3m 79

Technical
Service
Bulletin

Professional Audio Service Bulletin

FIGURE 4

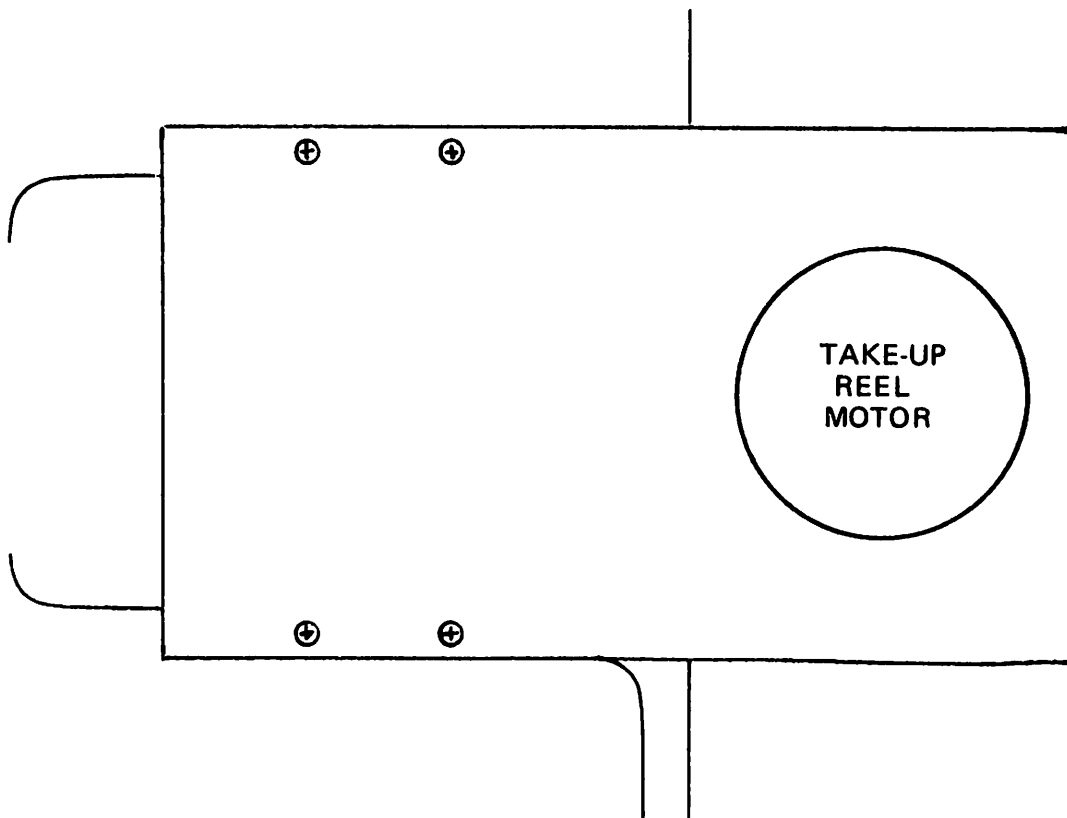
2. Modify the recorder to match figure 1 as follows:
 - a. Relocate support bracket using the template (figure 5) to locate the holes to be drilled.
 - b. Relocate the stop post so it is centered approximately 1 inch behind the pulley (see figure 1) by drilling a 1/4 inch hole and glueing in post.
 - c. Remove existing arm and replace it with a new 11 inch arm (part of conversion kit).
3. Disconnect supply and take-up motor connectors from wiring connectors; remove the four (4) screws holding each reel motor mounting plate and remove motor assembly (see figure 3).
4. Install motors on new motor mounting brackets (supplied in kit).
5. Install reel motor assemblies on recorder top plate (see figure 4). Install harness assemblies (supplied with kit) between respective motor assembly connector and wiring connectors.
6. Install new tape transport cover (supplied with kit).

FIGURE 6

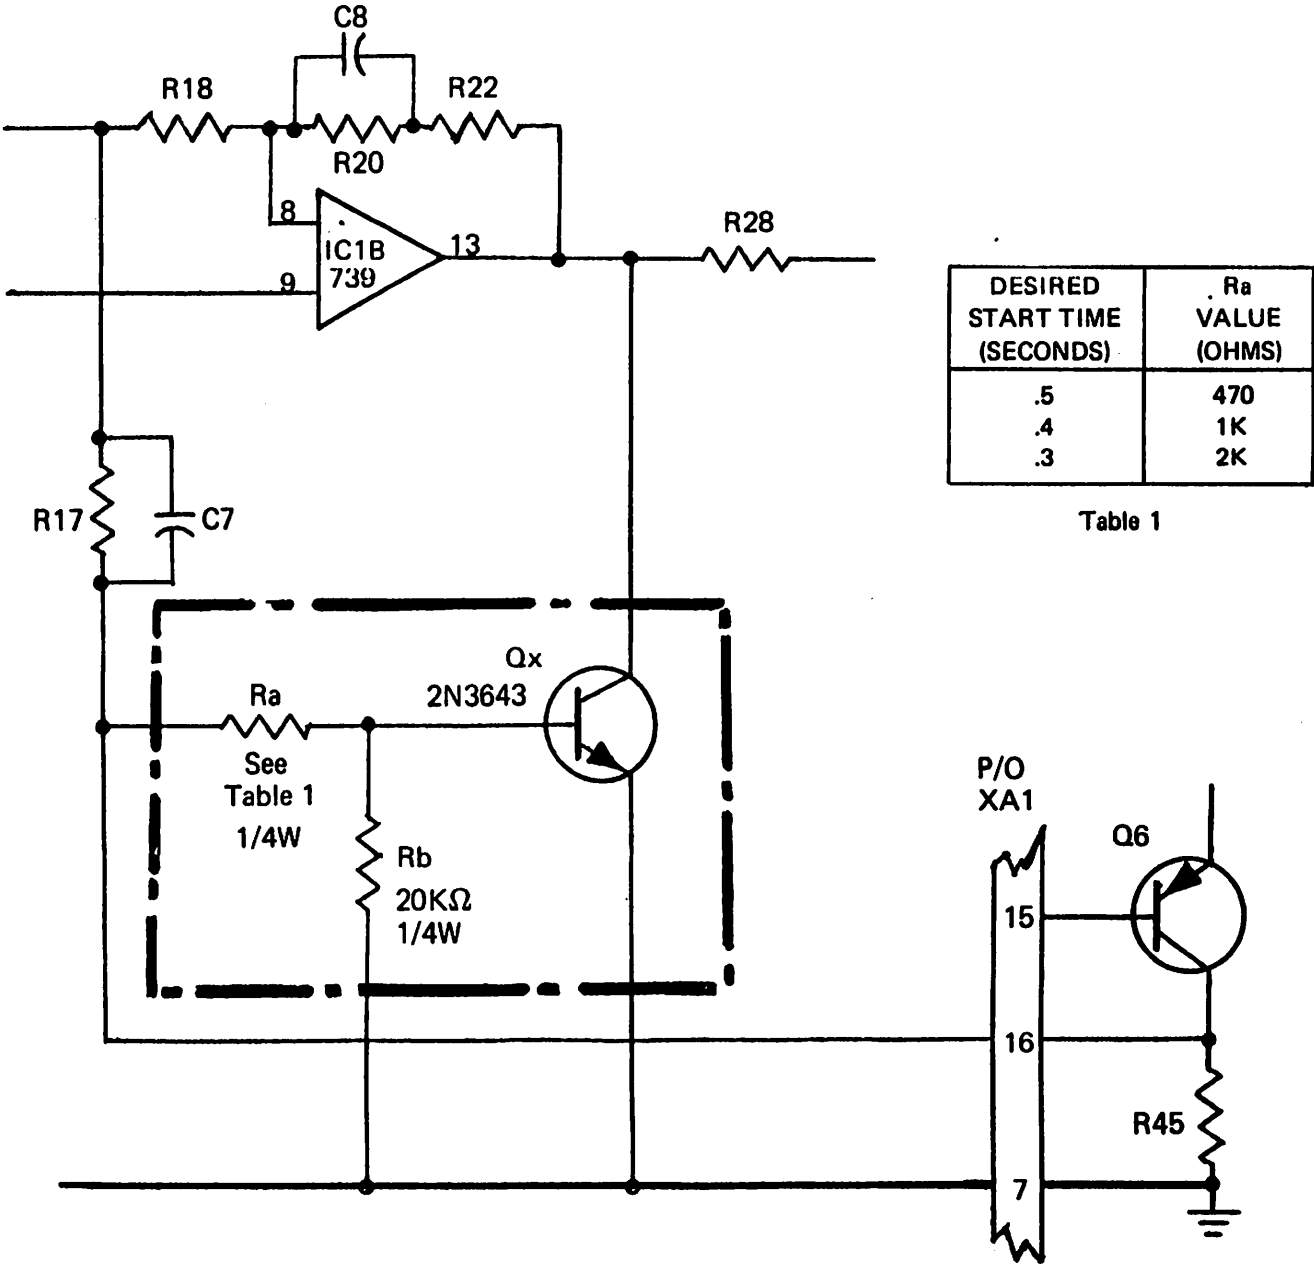
7. Modify Capstan Servo p.c. board (see figure 6).
 - a. Connect resistor Rb between GROUND and the base of Transistor Qx.
 - b. Connect resistor Ra between the junction of R17 and C7 (junction nearest to p.c. board side) and the junction of Rb and Qx base.
 - c. Connect the emitter of Qx to ground.
 - d. Connect the collector of Qx to the junction of R28 and IC1B pin 13.
8. Adjust capstan servo p.c. board pulse width and speed if necessary.
9. Perform reel alignment procedure.

FIGURE 1

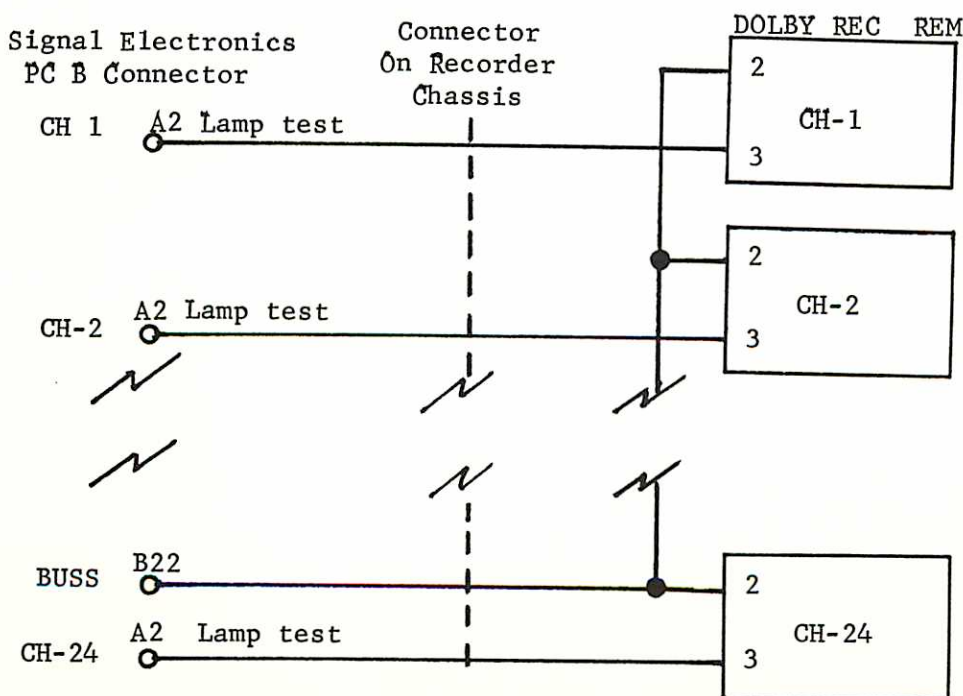
Remote connection of M series DOLBY units to M-79 (see figure 1).

1. Connect pin A-2 of each channel signal electronics pc board to pin 3 of the DOLBY unit through a suitable connector on the recorder chassis.
2. Connect pin B-22 bus on signal electronic pc board pin 2 of ALL DOLBY units.
3. Insure R102 and R108 in CAT 44 Interface Module are 6.8 K ohms (earlier models had 2.7 K ohm or 3.3 K ohm resistors); if the resistors are not the correct values, replace them with resistors of the correct value.

FIGURE 2

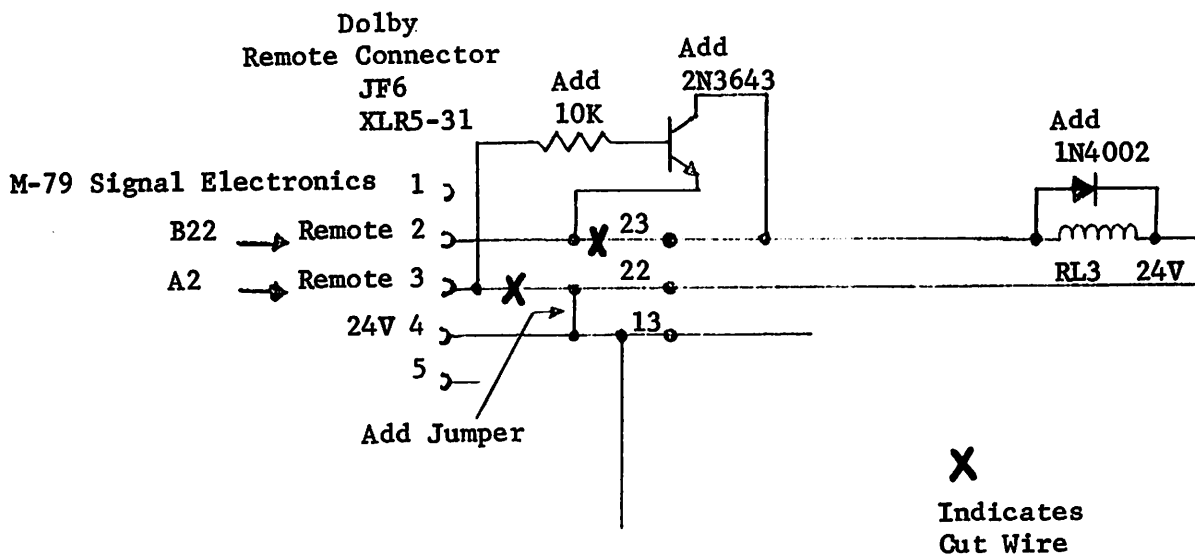
1. Connect Pin A2 of each M-79 Signal Electronics PC Board to Pin 3 of the DOLBY Remote Connector through a suitable connector on the recorder chassis.
2. Connect Pin B-22 buss on the M-79 Signal Electronics PC Boards to Pin 2 of ALL DOLBY units.
3. Modify DOLBY interface by adding circuit as shown in Figure 2.
NOTE: Refer to DOLBY 361 Interface circuit in the DOLBY Manual.

FIGURE 1

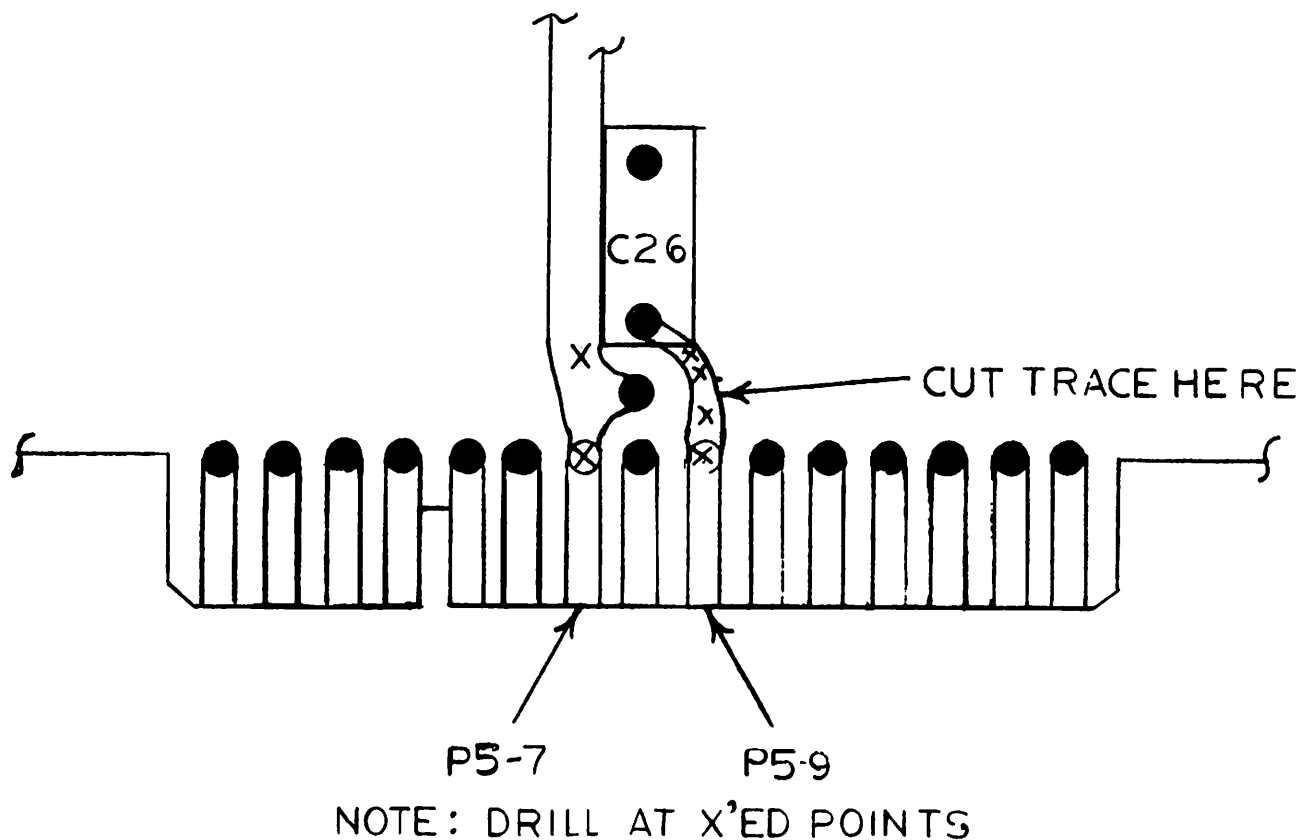
- V. Utilizing the drill motor and the #70 twist drill, put 6 holes thru the PC Board. Location of these holes are as follows: (See Figure I)
- A. Top of Contact Finger #9
 - B. Top of contact Finger #7
 - C. Between contact Finger #9 and cut in trace.
 - D. In trace running to the left of C-26 near lower left hand edge of C-26.
 - E. Between cut in trace and bottom of C-26, drill 2

FIGURE 2

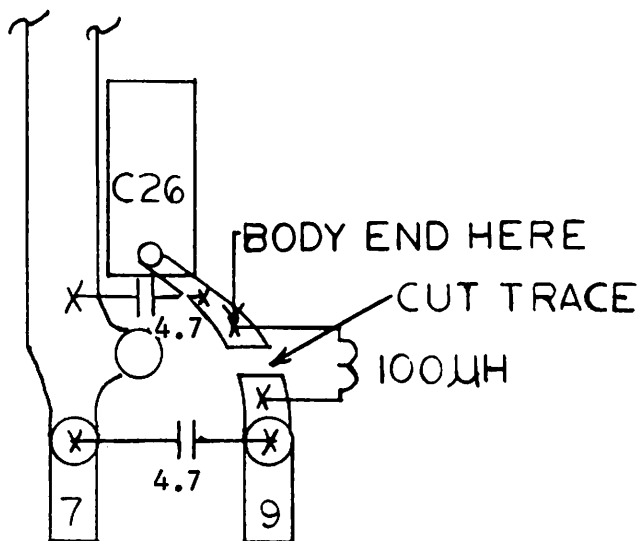
- VI. Install 4.7uf capacitor between holes drilled at top of contacts 7 & 9.
(See Figure 2)
- VII. Install 4.7uf capacitor between holes drilled just below and to the left and right of C-26. (See Figure #2)
- VIII. Install 100 μ h coil in two remaining holes (See Figure 2)

FIGURE 1

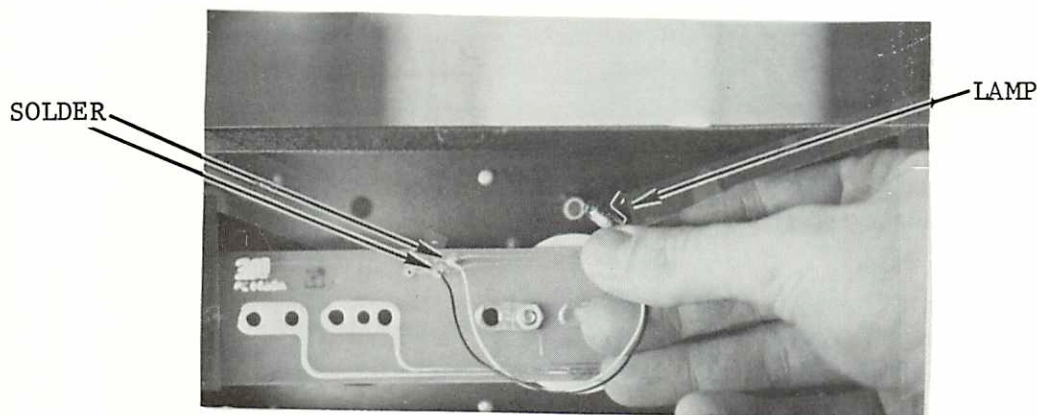
- I. Remove MURA type meter lamp from the white line cap above the meter and unplug the wires from meter mother board.
- II. Solder wires on lamp holder 83-1620-0294 in place of the removed wires on the mother board (see Figure 1).
